AGENDA
VILLAGE BOARD MEETING
Tuesday, March 9, 2021 at 7:30 p.m.
Jackson Village Hall
N168 W20733 Main Street
Jackson, WI 53037

SECTION 00 63 63 CHANGE ORDER

Change Order No. 5

VILLAGE OF JACKSON
MUNICIPAL COMPLEX
STATE HWY 60
JACKSON, WI 53037

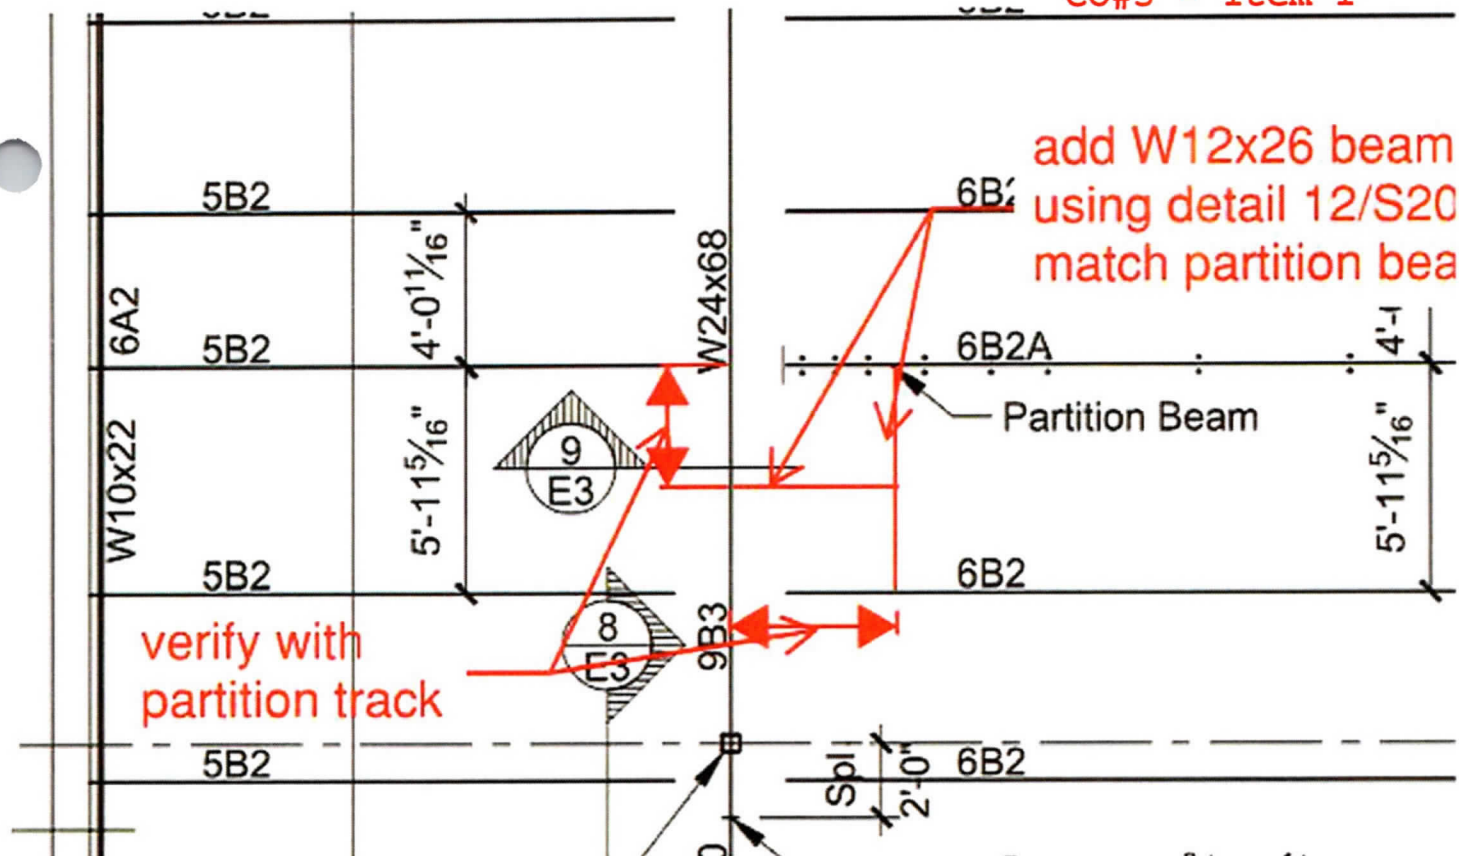
See the mark up below for the additional beams for the partition wall support.

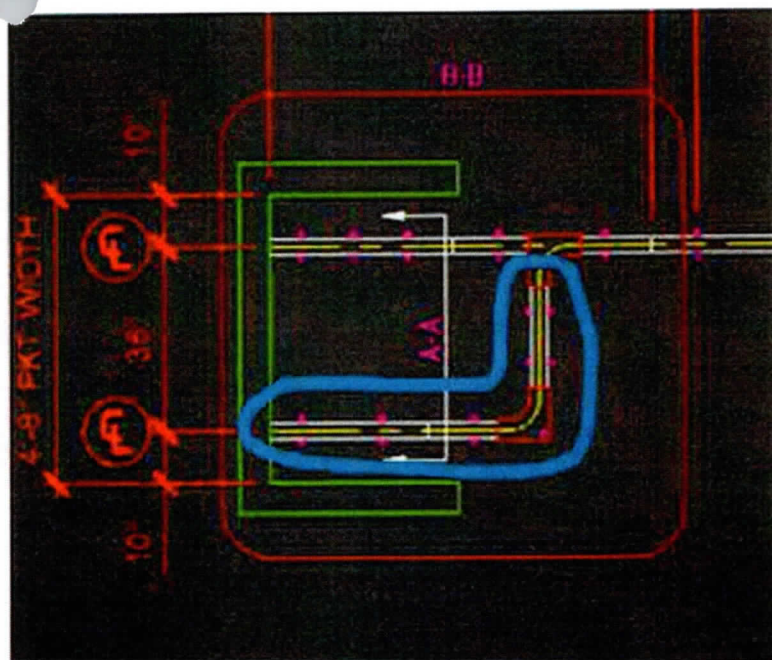
Thank you for this clarification, however there is still an additional question. Please see the following from the steel fabricator.

They addressed the main beam, but didn't address the conditions at the pocket. At the end of the partition wall where the wall accords into the pocket, there needs to be some sort of hanger beams to support the wall in the pocket. I pasted the relevant section of the JWC drawing below and circled in blue. As depicted below,

these beams can be a smaller dimension than the main beam as long as bottom of steel lines up. However, we need to know the size of the beams and how the structural engineer would like us to support these beams (i.e. can the beams support the weight just by tying into beam 9B3 & the 6B2 main hanger beam or do we need to add in a column someplace).

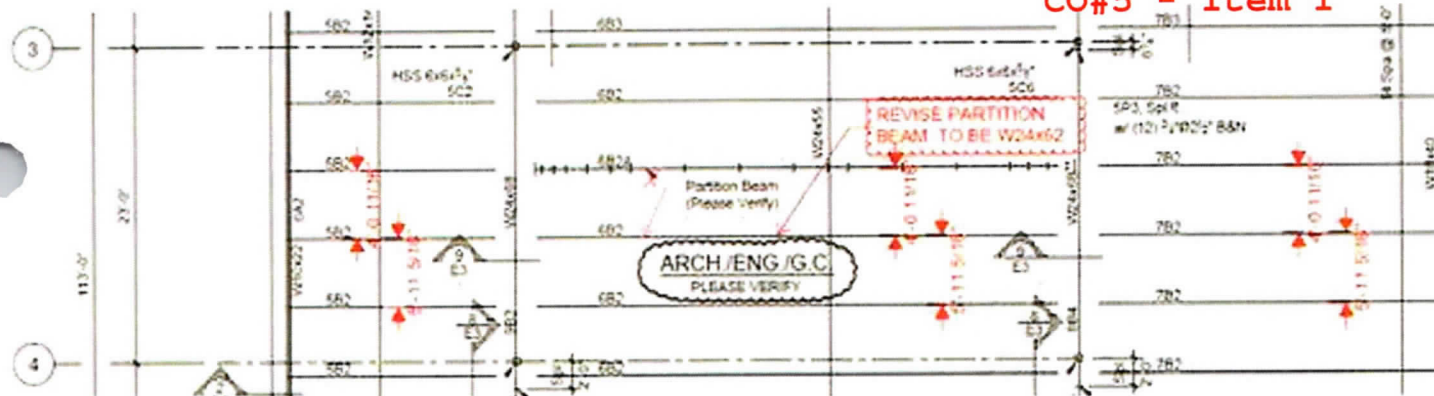
Initially, when we responded to the RFI. We were going to complete this with Unistrut system, but after reviewing the structural steel submittal, we decided that this could be done by sliding a beam approximately 11 5/16" to the north to line up with the partition wall. In doing this, we will need to increase that beam to a 24x62 to handle the load. This was marked up on the first shop drawings. I forgot to send you a note on this to include for pricing. Below is a snip from the submittal to show you what we are looking to revise.

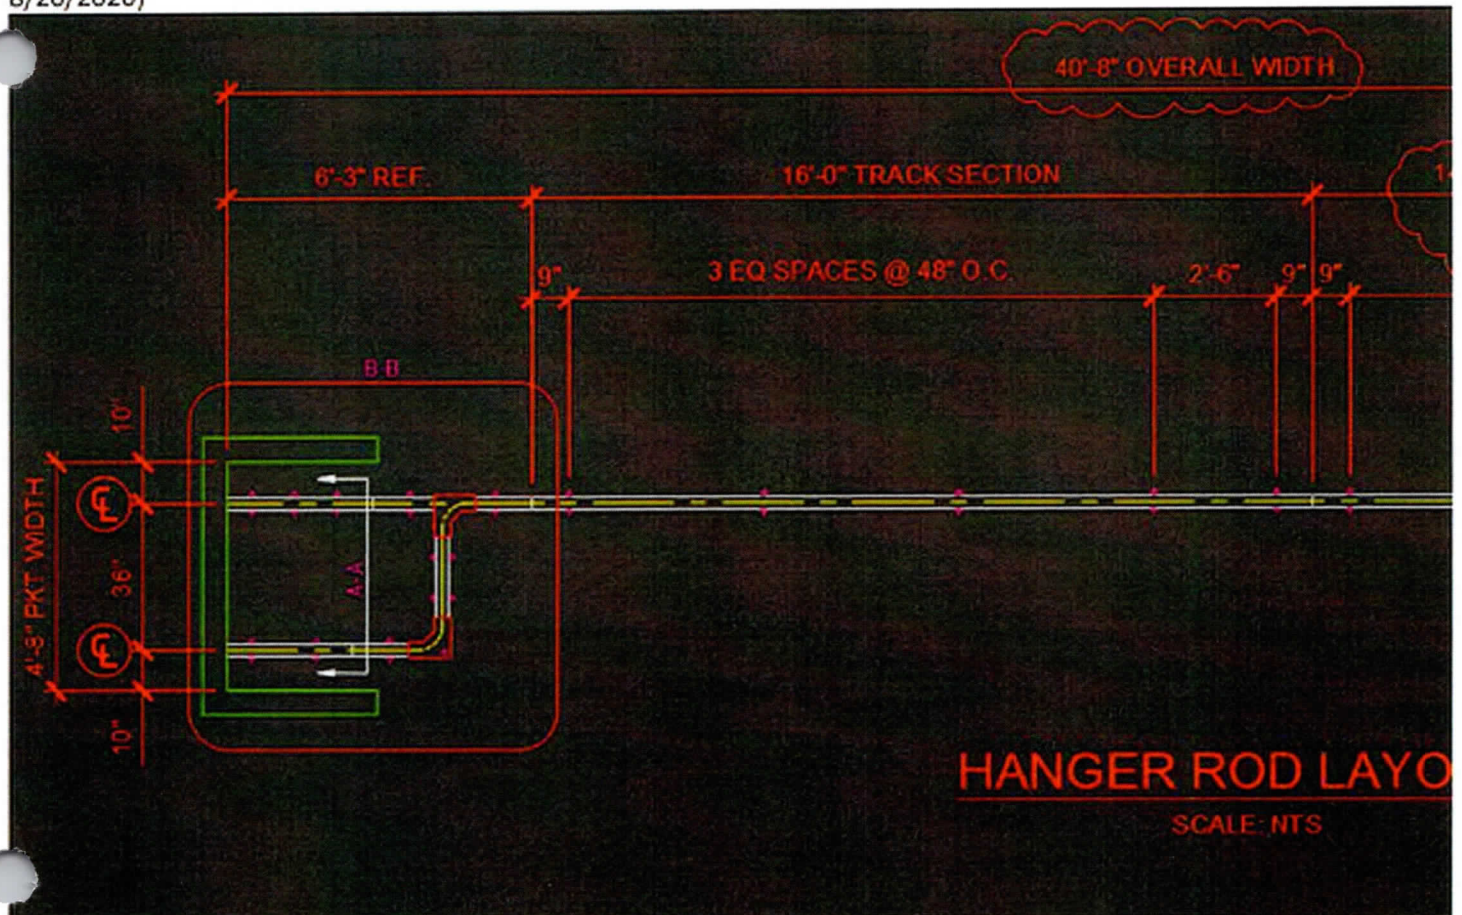
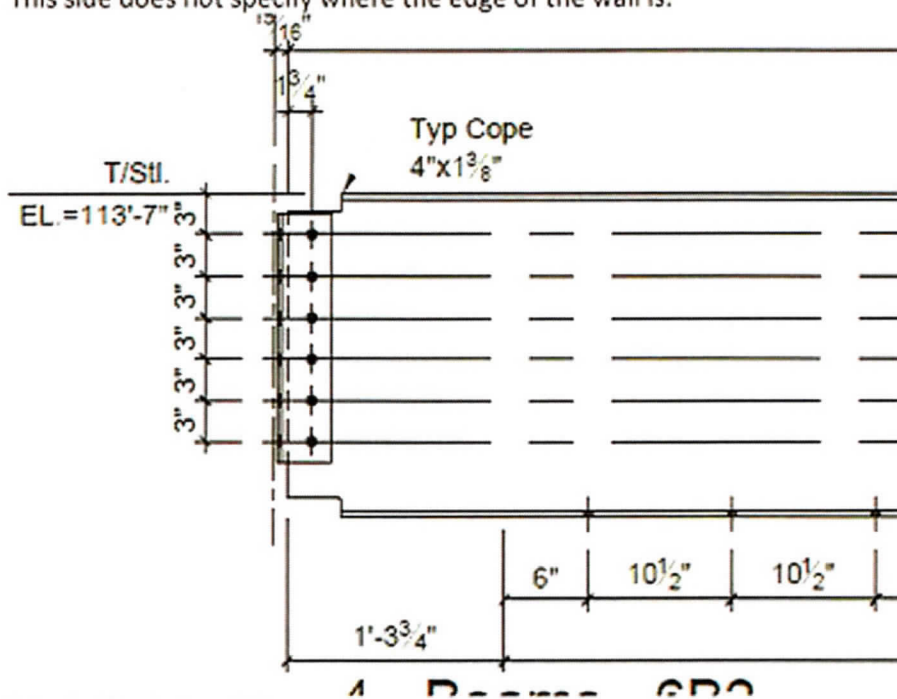
Pete, our hanger rod layout is based off finished wall conditions. (Please note the maximum overall width we can do – emailed

This side does not specify where the edge of the wall is.

It looks like it should be good enough.

ENLARGED
SECOND FLOOR
PLAN "F"

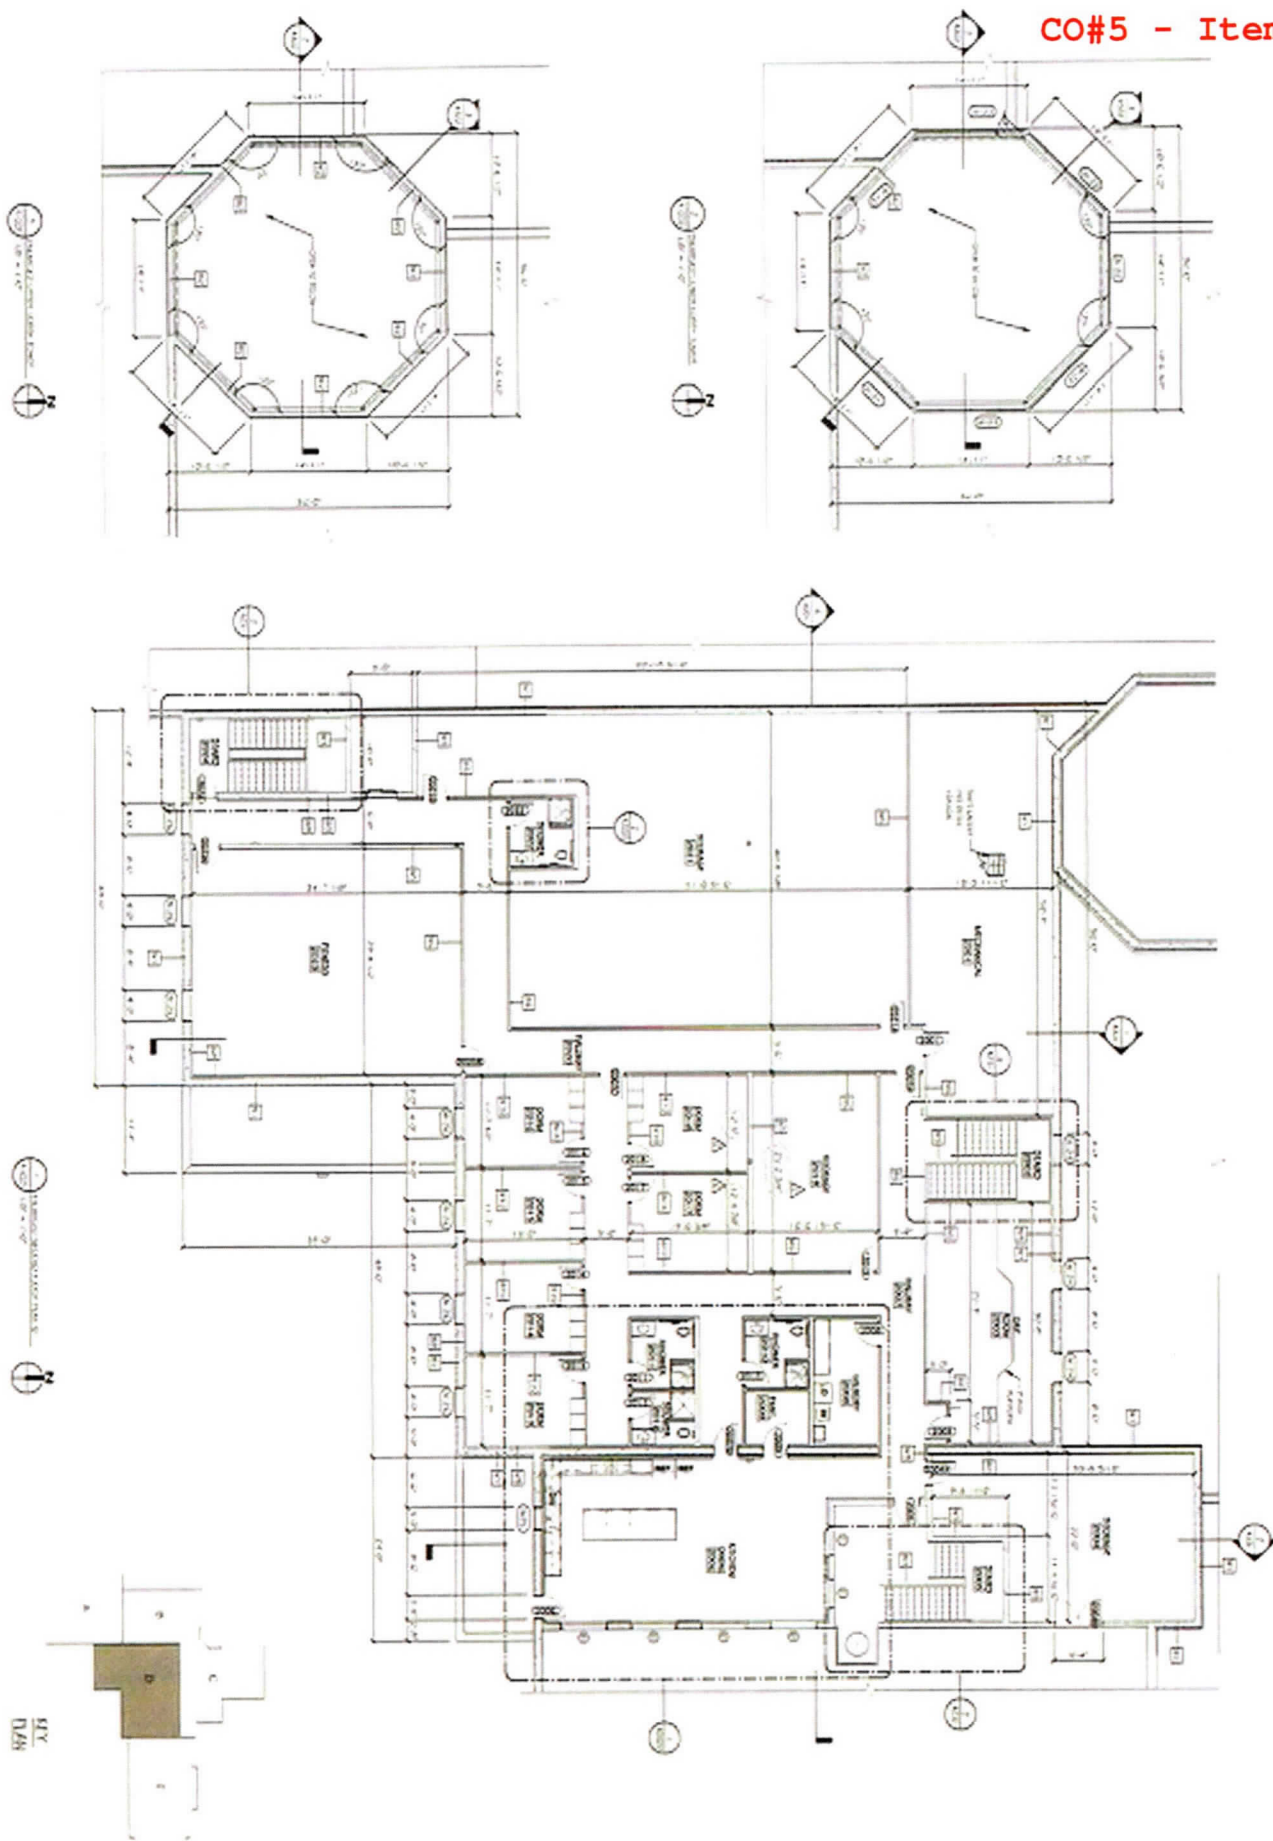
Please, see the attached plan with clouded revisions to address the shower inserts to fit in rooms. We will be working through the showers on the first floor and get those to you as soon as possible.

PLUMBING
PLANS

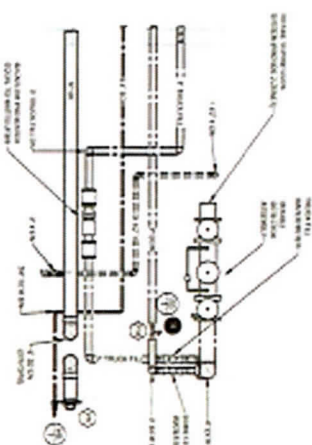
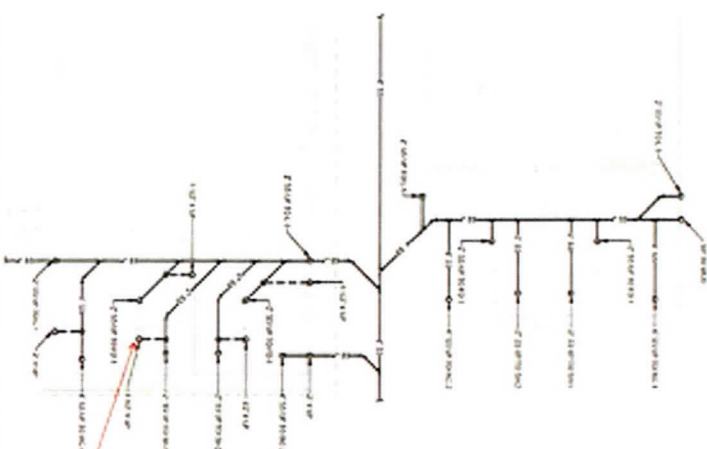
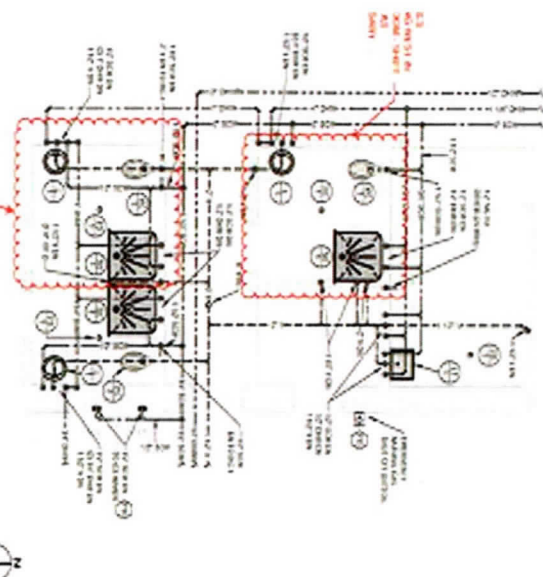
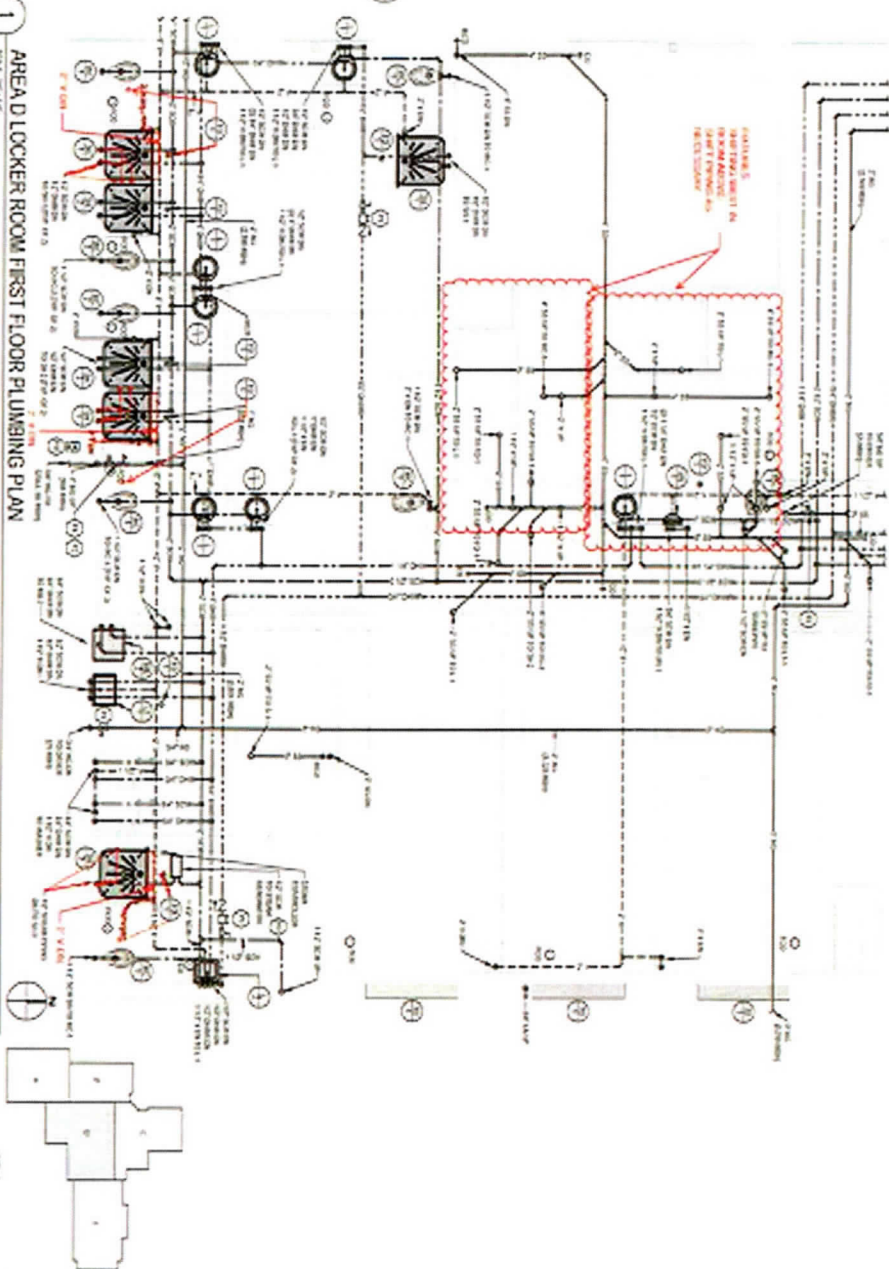
- This change order is for relocating (3) floor drains in section D.
- The floor drains needed to be relocated to the entrance of the (3) rotated ADA showers.

Attached please find PCO #22 as approved by the Owner and related to the revised locations of floor drain locations associated with the accommodation of ADA restroom clear space requirements. Please proceed with this work accordingly.

DRAWING SHEET REF: A102D

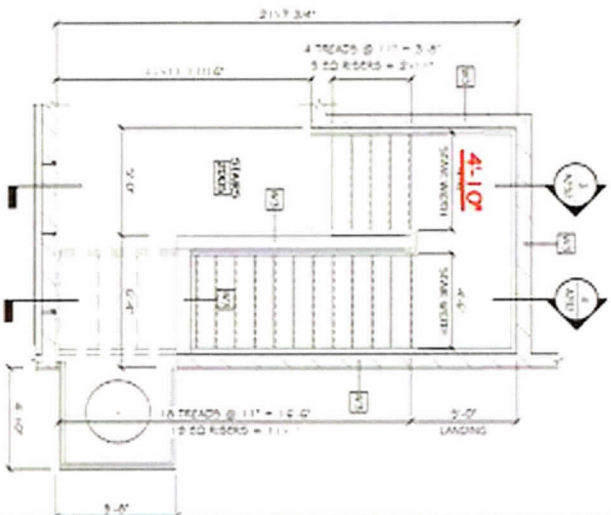
In regard to the Request for Cost Proposal associated with the Precast Plank Support - Bldg D Stairwell 2D05, we'd like to revise the request to include cost considerations related to the change in wall types directly related to the change in floor structure.

Therefore, in addition to the cost proposal related to the precast plank support, please include within the proposal the cost impact related to revising the following plan CMU walls sections to a 6" steel stud/gypsum wall construction:

- Provide and install precast support steel header
- Delete masonry wall 2 storage room masonry wall
- Replace deleted masonry walls with 6" steel stud and gypsum board wall
